Proposal #23: 1197-00-70, WISC 2021 042
Spoooner - Minong
Trego Interchange
USH 053
Washburn County

This is Addendum No. 01, which provides for the following:

ADDENDUM NO. 01
PROJECT ID 1197-00-70
November 30, 2020

Addendum No. 01
 ID 1197-00-70
 Added Sheet 31A
 November 30, 2020

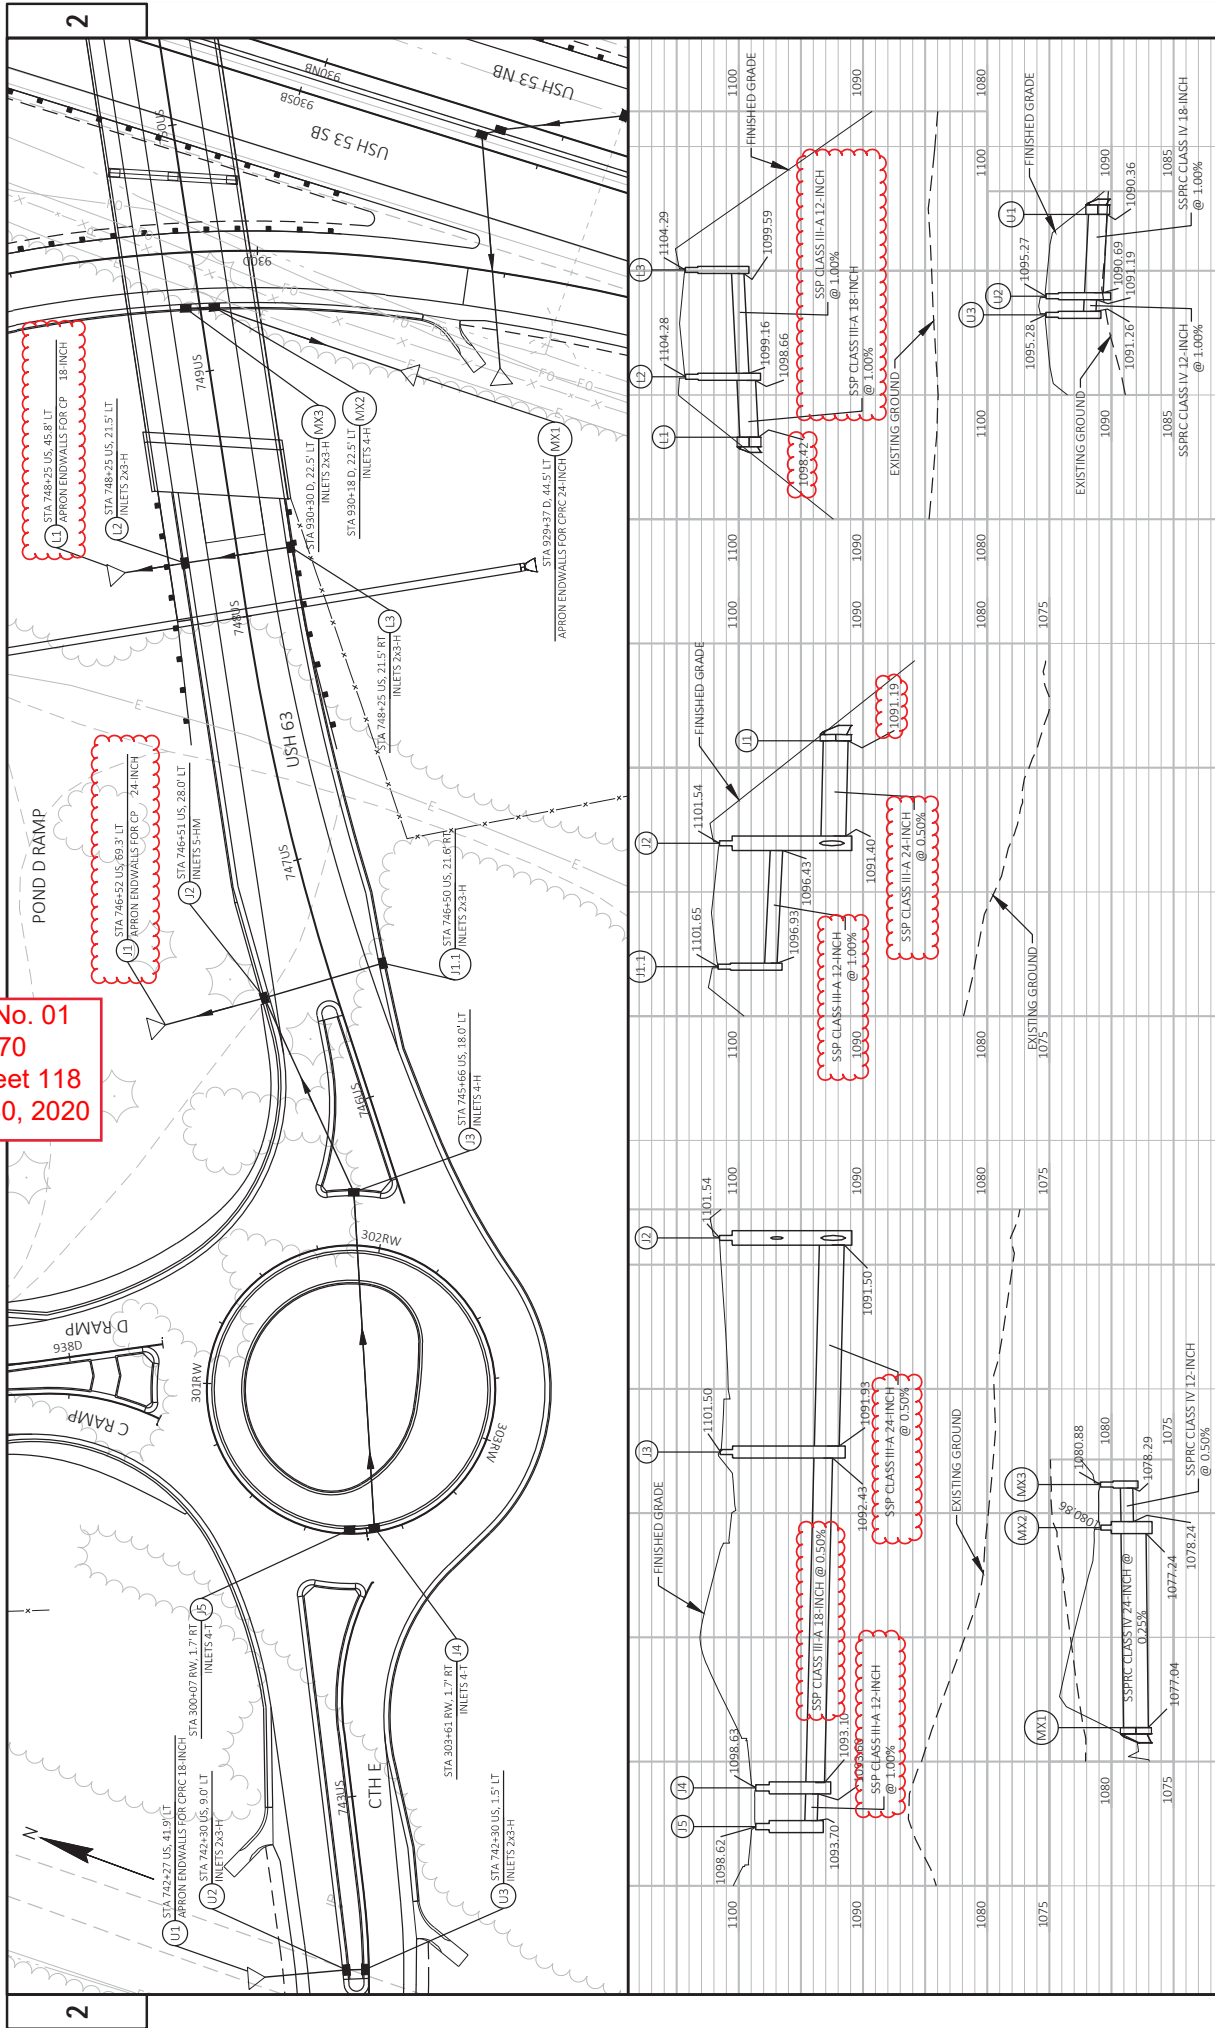
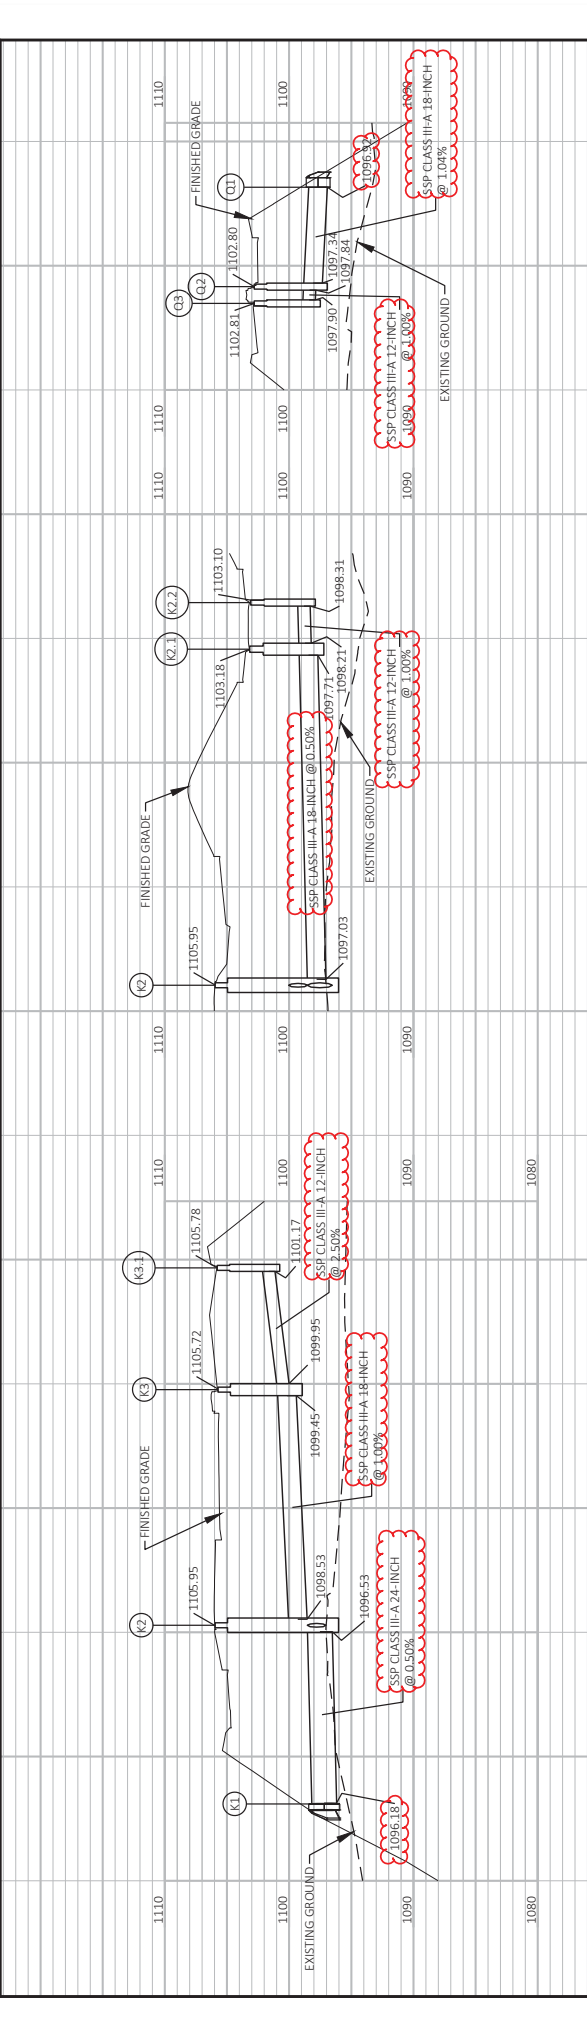
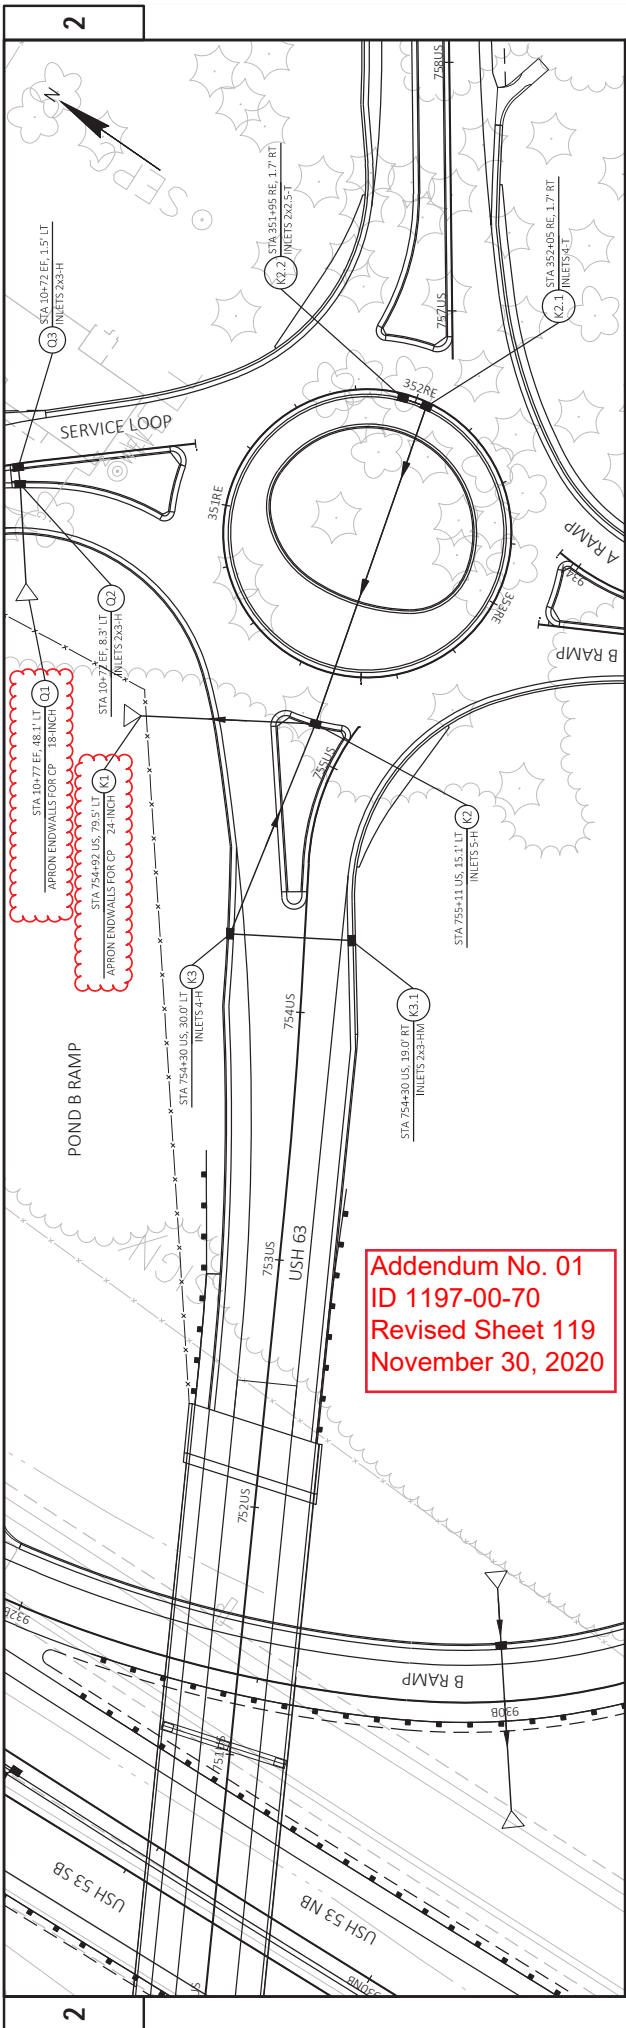
Added Plan Sheets	
Plan Sheet	Plan Sheet Title (brief description of why sheet was added)
31A	Construction Detail – Potential Waste Sites – included to show potential sites that waste could be placed from this project.

NOTES:
 USE 3:1 MAX SLOPES IN WASTE AREA.
 DO NOT PLACE SLOPES STEEPER THAN SHOWN ON THE TYPICAL SECTIONS IN THE CLEAR ZONE.
 COMPLETE A DRAINAGE ANALYSIS SHOWING ANY CHANGES TO THE DRAINAGE DESIGN BASED ON PROPOSED FILL LAYOUT.
 COMPLETE ALL REQUIRED PERMITTING (SIMILAR TO PRIVATE WASTE SITE).
 FILLS PLACED GREATER THAN 10' WILL REQUIRE BENCHING.
 APPROXIMATELY 40,000 CY OF WASTE MAY BE PLACED IN THESE AREAS. ADDITIONAL WASTE SITES AS NOTED ON THIS SHEET WILL BE CONSIDERED. SUBMIT A CONTOUR PLAN FOR APPROVAL PRIOR TO WASTING MATERIAL AT THESE LOCATIONS. VOLUMES SHOWN ON THIS PAGE ARE APPROXIMATE AND FINAL VOLUMES WILL BE BASED ON CONTRACTOR'S CONTOUR PLAN.

Addendum No. 01
 ID 1197-00-70
 Revised Sheet 374
 November 30, 2020

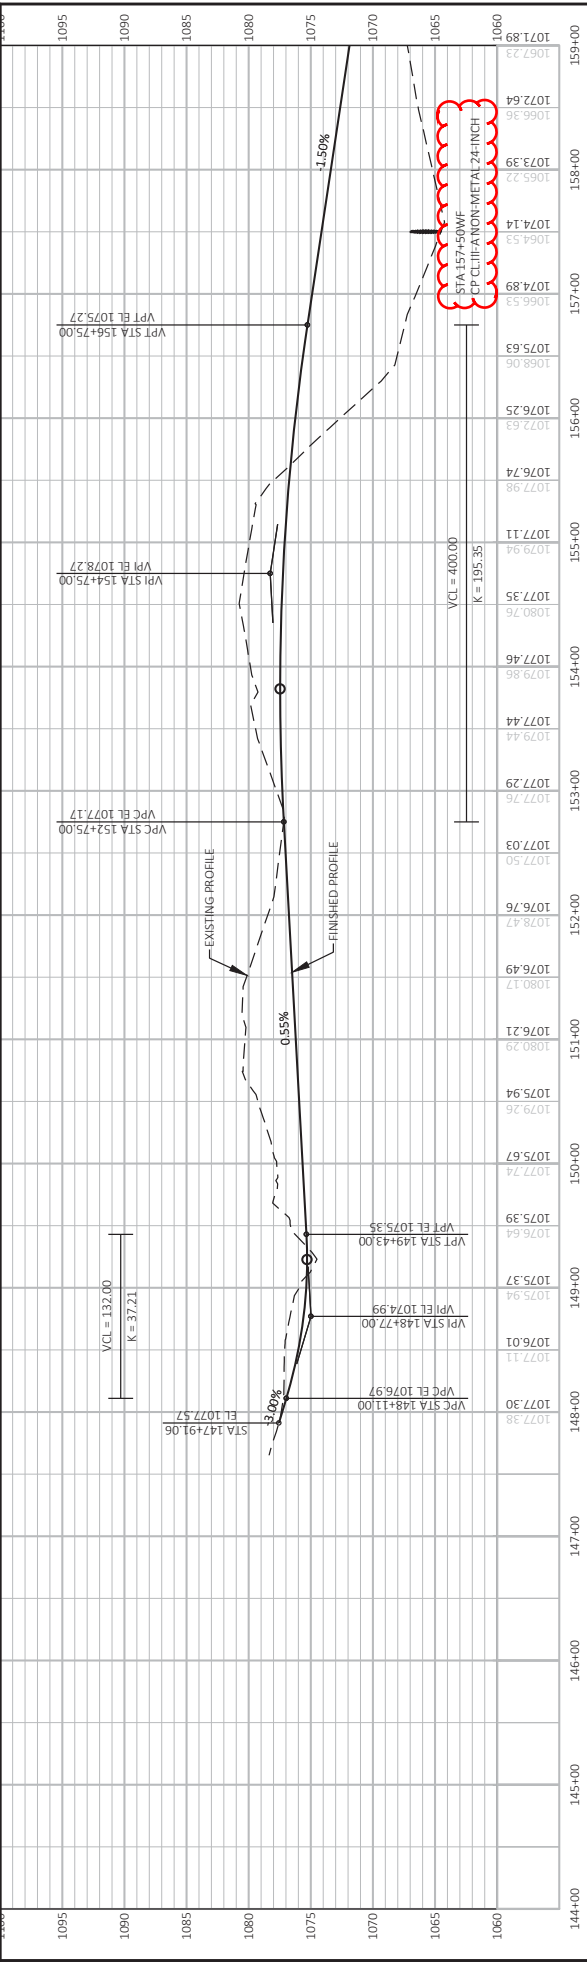
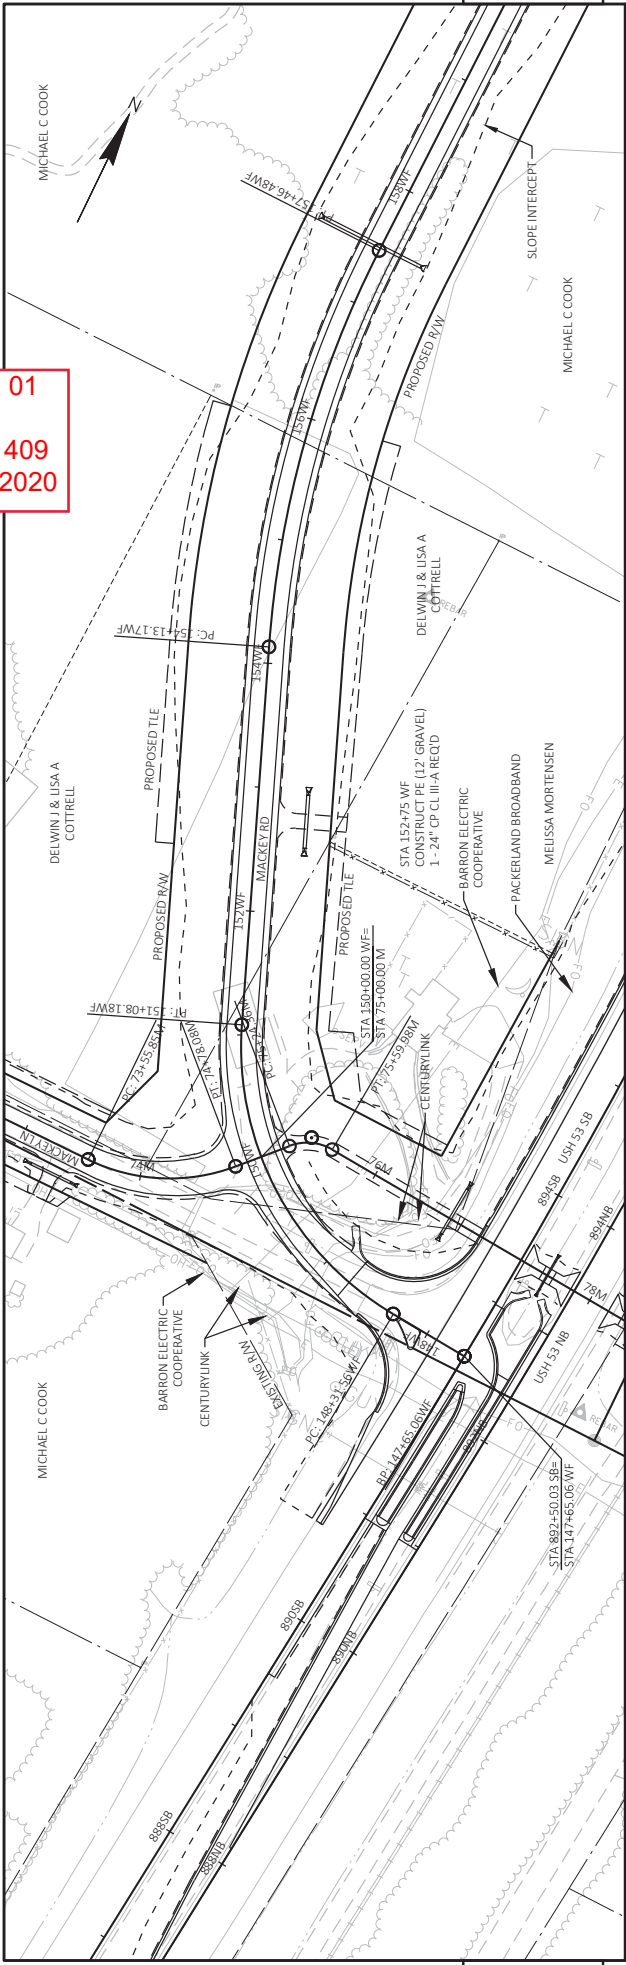
Revised Plan Sheets	
Plan Sheet	Plan Sheet Title (brief description of changes to sheet)
118	Storm Sewer – USH 63 – Pipe material update
119	Storm Sewer – USH 63 – Pipe material update
347	Miscellaneous Quantities – Pipe material update
349	Miscellaneous Quantities – Pipe material update
357	Miscellaneous Quantities – Update to bid item
372	Miscellaneous Quantities – Pipe material update
374	Miscellaneous Quantities – Pipe material update
409	Plan and Profile Sheet – Pipe material update
411	Plan and Profile Sheet – Pipe material update
412	Plan and Profile Sheet – Pipe material update
707	Structure B-65-56 – Updated quantity for fence
782	Structure R-65-3 – Updated quantity for Concrete Masonry Retaining Walls
968	Cross Section - Pipe material update.
989	Cross Section - Pipe material update.
995	Cross Section - Pipe material update.

Addendum No. 01
ID 1197-00-70
Revised Sheet 782
November 30, 2020

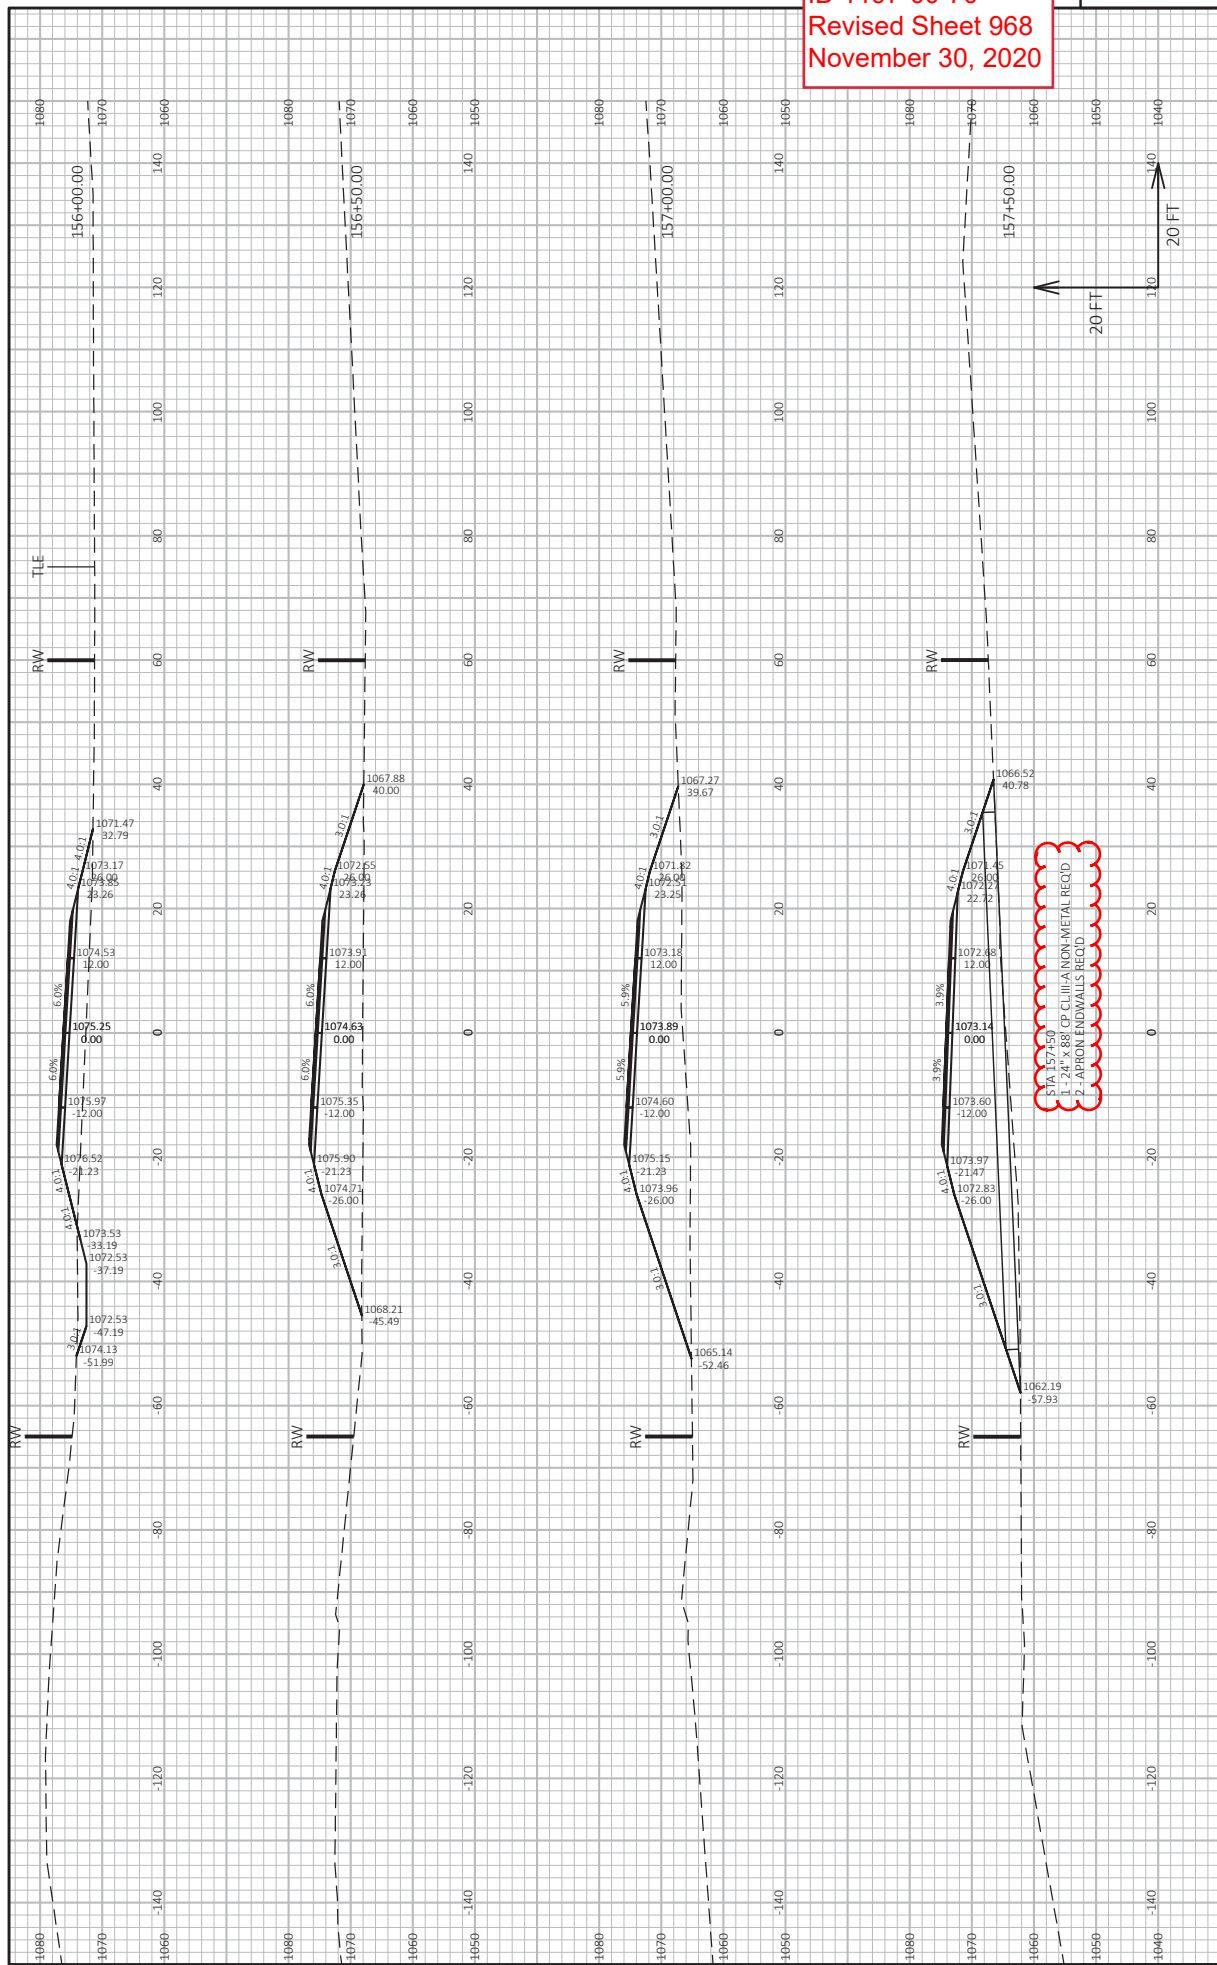
CONCRETE QUANTITY CHANGE
MWB
BY
STATE OF WISCONSIN
DEPARTMENT OF TRANSPORTATION
STRUCTURES DESIGN SECTION
STRUCTURE R-65-3
BY
MWB
MWB/C.T.D.
A.A.
